Amendment C10/11 edition 2.3 of 15 October 2025

Subject: Allow the use of P1 port as alternative to an EnFluRi sensor

1 CONTEXT OF THIS AMENDMENT

Figure 2 – Example of a DC-connected energy storage system (hybrid system)

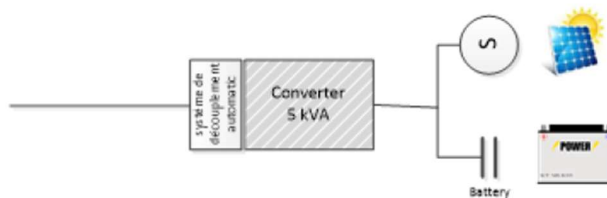
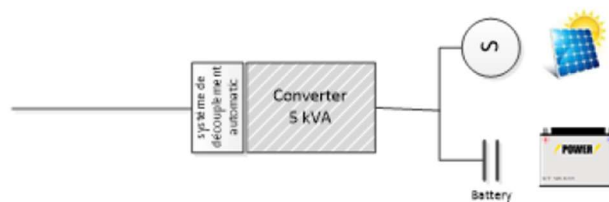
- An energy storage system that have the possibility to inhibit power injection into distribution network by software (with the exception of a non-parametric firmware out of the factory out of the factory) is considered being technically able to supply energy to the distribution network and therefore covered by this definition.
- A direct current connected energy storage system with another means of power-generation is considered a non-synchronous power-generating unit, and is also called a hybrid system.
